City of Santa Fe, New Mexico

memo

2026-012977-HDRB. 527-A Agua Fria St., Westside-Guadalupe Historic District. Contributing. Osage Design Studio, agent for Neirika, LLC, owner, proposes to relocate the garage door opening. An exception is requested to 14-4.6(E)(4)(II)(c) for recreating a missing feature without replication.

Figure 4: Previously Approved Floor Plan and the Proposed Floor Plan

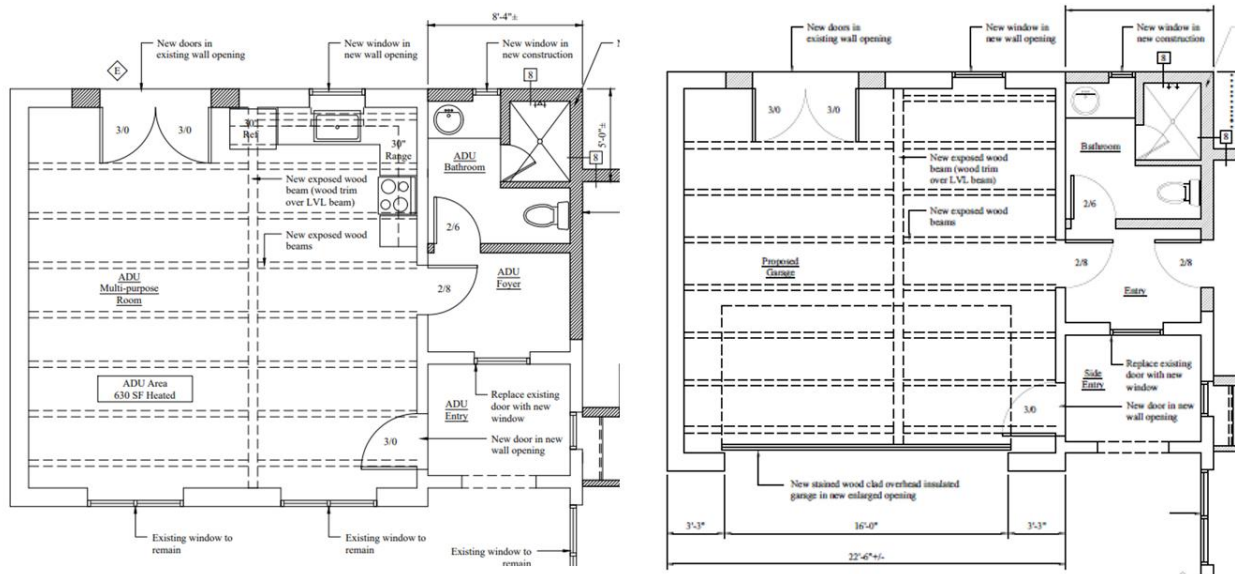
- 1) Create a single garage door on the non-primary south façade. The door will be a wood carriage door style.

This façade historically held two garage doors, which were replaced with windows.

Figure 5: The Historic Openings, Current Openings, and Planned Opening

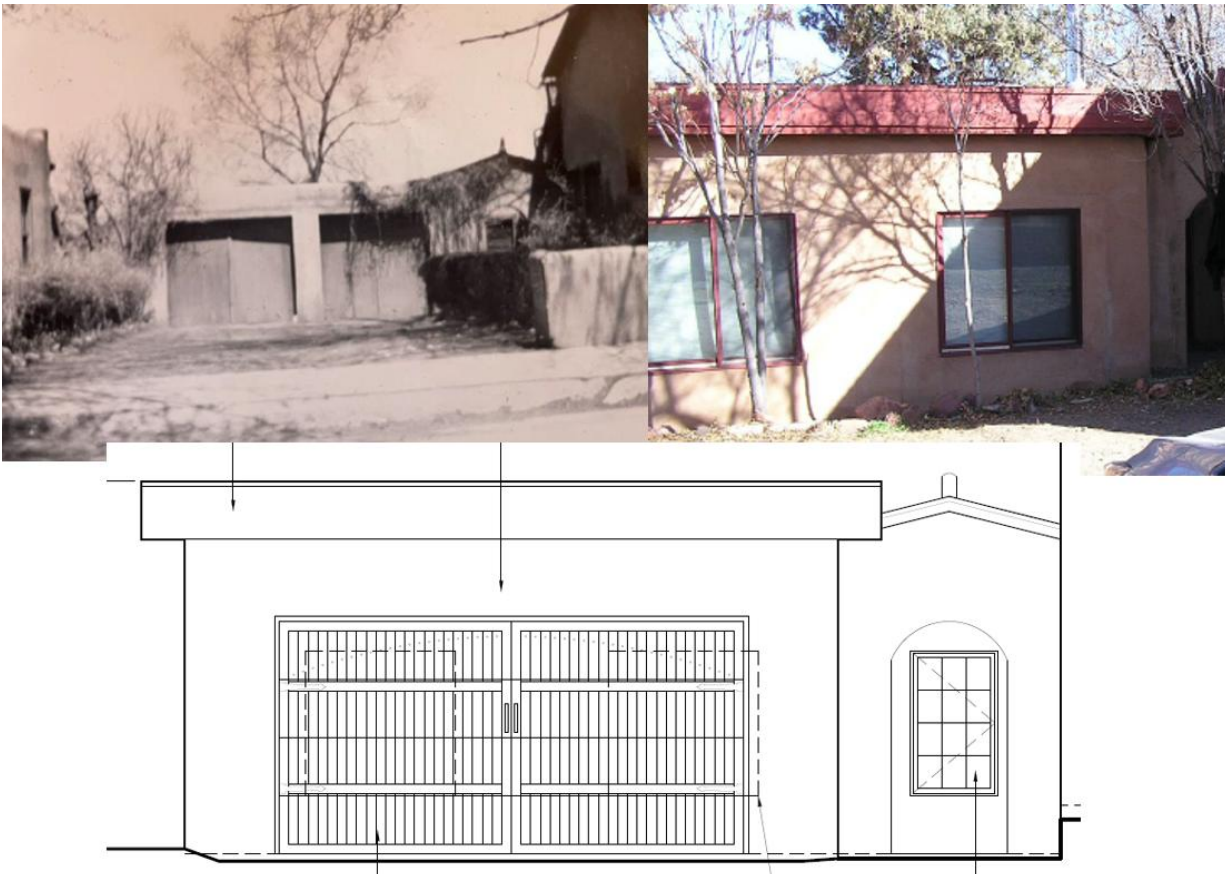
Exception to 14-4.6(E)(4)(II)(c): The applicant requests an exception to recreate a missing feature without replication.

Applicant Response: The Applicant considered two doors similar to the historic photo. For functionality, the Applicant would prefer a single door. Modern vehicles are often larger than historic vehicles. A wider single door would ease the maneuverability of a vehicle entering or exiting. Narrow double doors would create a hardship, as the future residents would not have free use of the garage.

Staff Response: Staff finds that this criterion is not met. There is a trade-off between parking flexibility and energy efficiency versus convenience and lower maintenance costs. Two single garage doors are more energy efficient; each door is independent, which results in higher costs for maintenance and installation. A single double garage door is usually 16-18 feet with no center post, making it easier to park large trucks, maneuver trailers, or swing car doors open. The cost of maintenance and installation is less since there is a single opening and door, but there is greater heat loss. Modern vehicles are larger and require more space for maneuvering than those that were initially parked in this garage. Therefore, the single door is the preference; however, staff does not find that this falls under a “hardship”.

Staff finds that the exception criteria to 14-4.6(E)(4)(II)(c) for recreating a missing feature without replication have not been met, and recommends denial of the exception request. Otherwise, staff recommends approval of the application as it complies with 14-4.6(E) General Design Standards for all Historic Districts, and 14-4.6(G)(5) Westside-Guadalupe Historic District Design Standards.
